ORIGINAL APPLICATION NO.69 OF 2022

REPLY ON BEHALF OF
RESPONDENT NO.10

Subject: Adequacy Assessment Report of Effluent Treatment Plant for Sugar Factory**Reference:** PKDNNHKASSK/MFG/2022-23/3277 dated: 05.01.2023

**Adequacy Assessment Report of Effluent Treatment Plant for**

Fig. 1: Treatment process flow in existing ETP

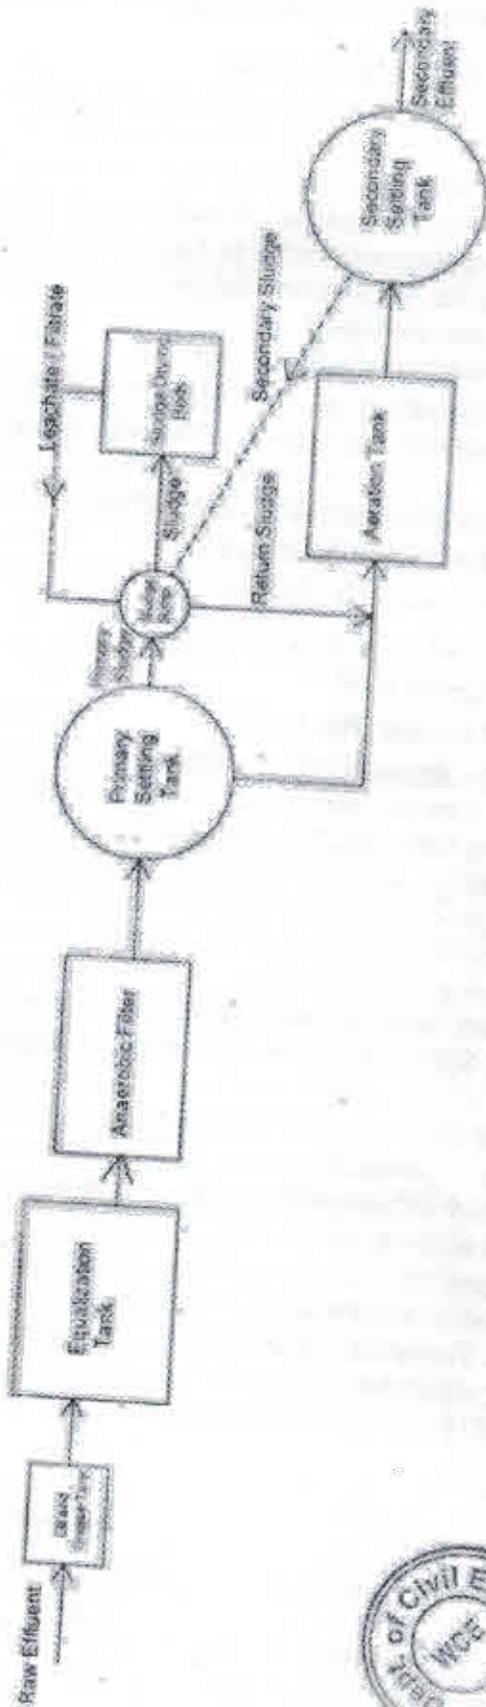
Fig. 1 shows the treatment process flow in the existing ETP. The existing ETP has an oil and grease tank, a flow measuring channel with "V" notch, an equalization tank, anaerobic filter, primary settling tank, aeration tank, secondary settling tank, sludge sump and sludge drying beds. The pumping system is provided to feed effluent from equalization tank to anaerobic filter, and sludge from sludge sump to sludge drying beds & aeration tank. As per the original design the equalization tank had two compartments separated by a partition wall and siphon pump conveying effluent from first compartment to the second compartment. Also equalization was installed with turbine type mixer. There are two surface aerators provided in aeration tank. There is a stirrer attached with scraper blade in primary and secondary settling tanks.

The process flow provided in the existing ETP is described in section 3.1. There is no bar screen provided in the ETP. The pretreatment with anaerobic filter followed by primary settling tank may not give the desired performance for the removal of soluble BOD. The feed from equalization tank to anaerobic filter contains suspended solids and will be sieved/filtered in anaerobic filter. The purpose of anaerobic filter is to remove soluble BOD by biofilm formation. The accumulated suspended solids will affect this activity and thereby result in poor performance in BOD removal. Further, the primary settling tank will not receive adequate suspended solids and hence it acts as flow-through tank with less settled sludge. Thus, the provision of anaerobic filter and primary settling tank in this sequence/configuration may not be useful for the removal of soluble BOD.

- i. A change in process flow with feed from equalization tank to primary settling tank and subsequently feeding the anaerobic filter. As a result, there will be more soluble BOD removed from the effluent that is fed to the anaerobic filter.

Fig. 2: Recommended upgraded treatment system for ETP

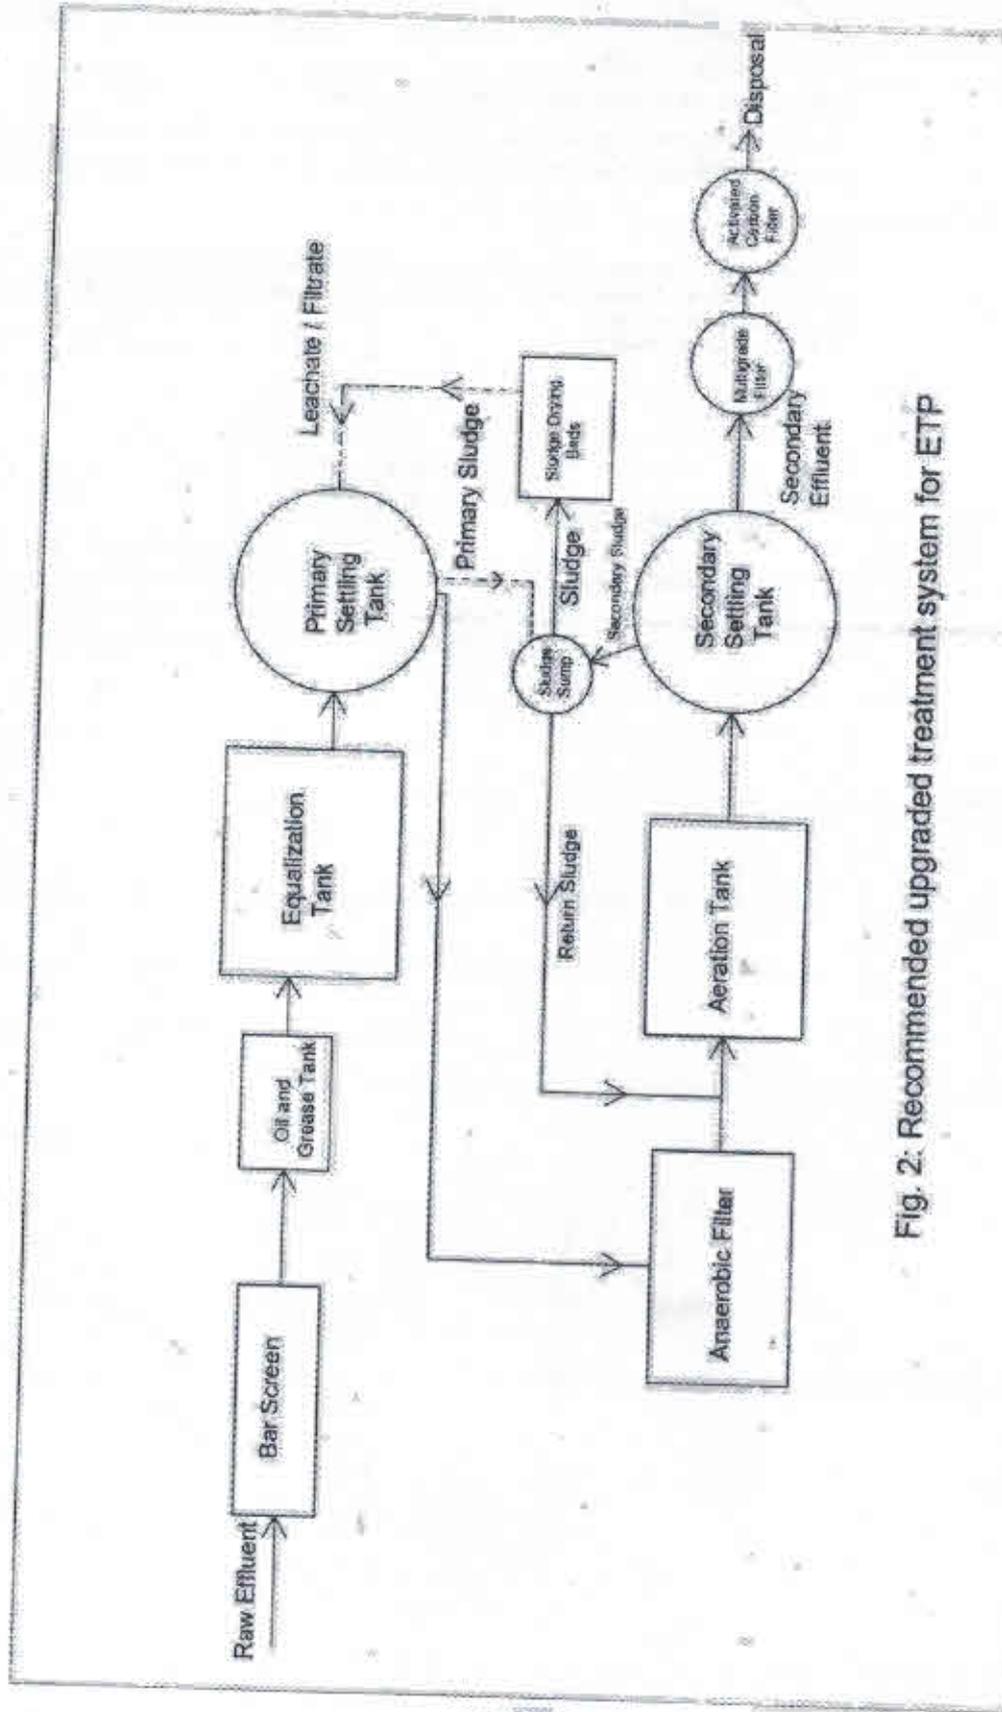
Fig. 1 shows the recommended and upgraded treatment system for ETP. The treated effluent should be chlorinated/ozonated before disposal. A monthly washing tank is required, but not shown in Fig. 2.
